Technical Service Bulletin: TSB200168

Engine Wiring Harness Routing

Figure 1, Wiring Harness Installed with Wire Ties

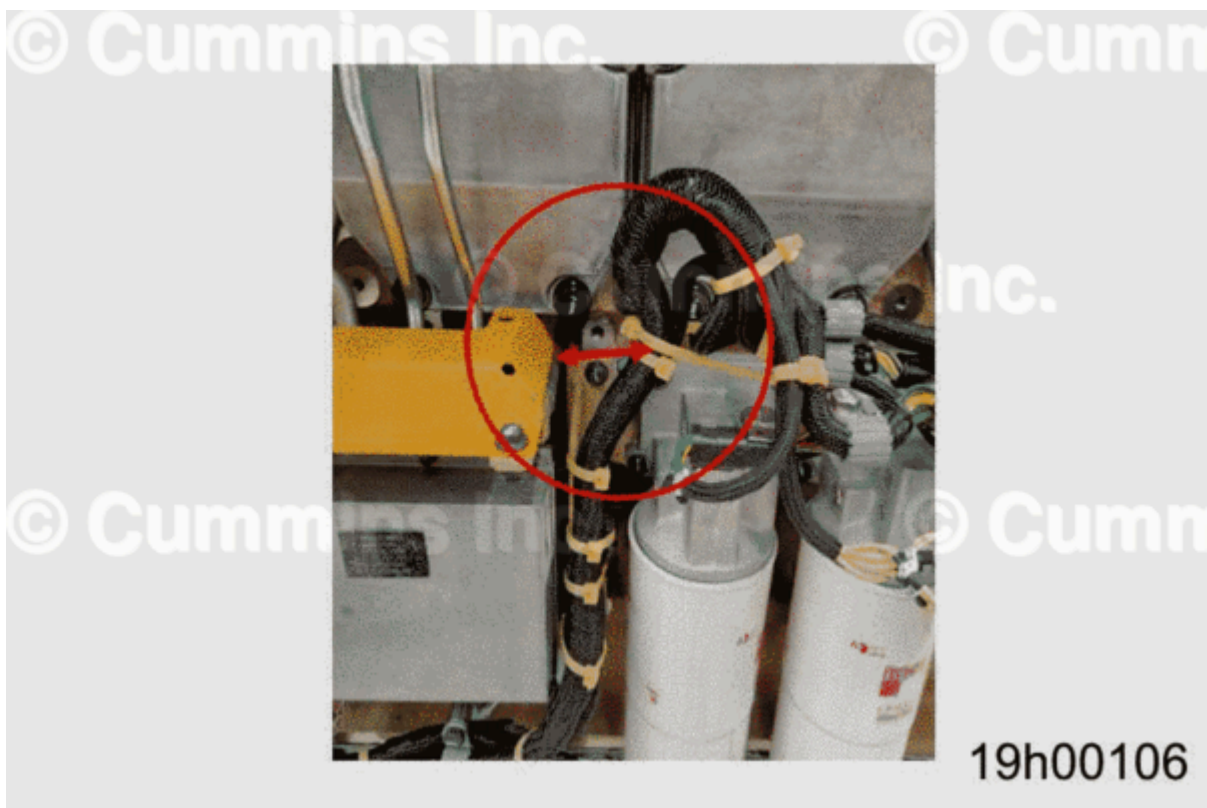
Engine wiring harness interference with the ECM cover plate.

- Engine wiring harness rubs through the ECM cover plate.

- Engine wiring harness routing not robust.

Add wire tie to hold the harness away from ECM cover plate to prevent interference. There should be a gap of at least 25 mm (1 in) between the cover plate and the wiring harness.

Wire tie the harness to prevent interference with the ECM cover plate.
